MASTERDRIVE®
POWER TRANSMISSION PRODUCTS

AK46-1

SIZE	DWG. NO.	REV
A	AK46-1.000	
SCALE: 1:2	WEIGHT:	SHEET 1 OF 1

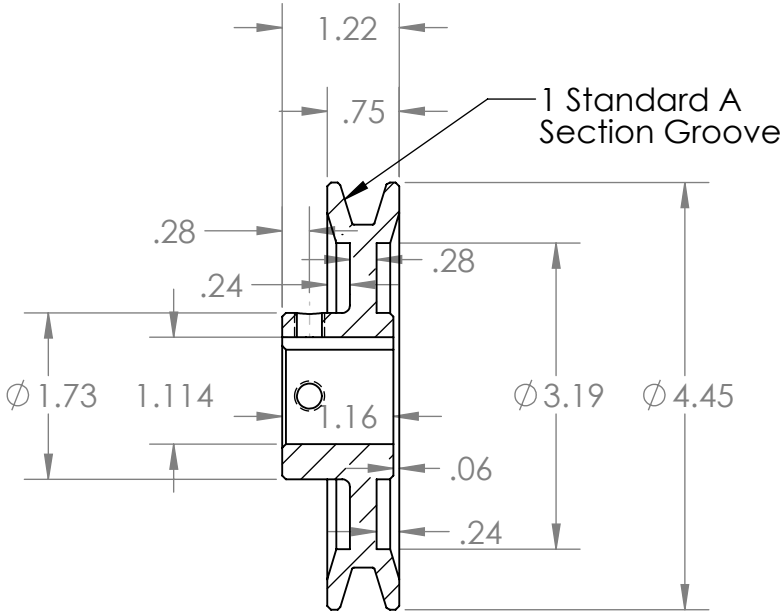
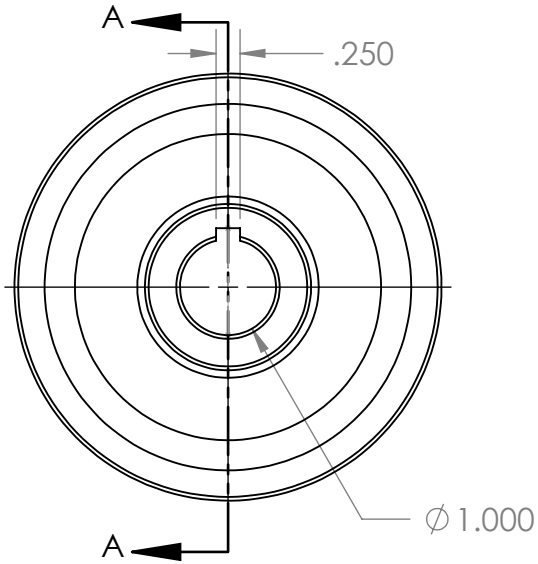
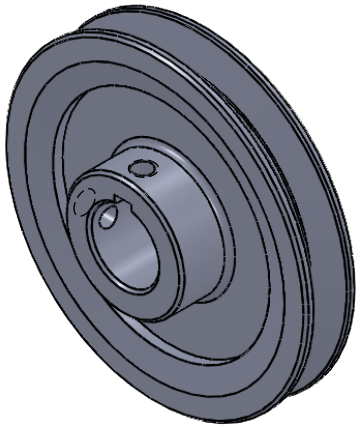
Note: 10/19/18 Hub diameter changed from 1.73" to 1.89"
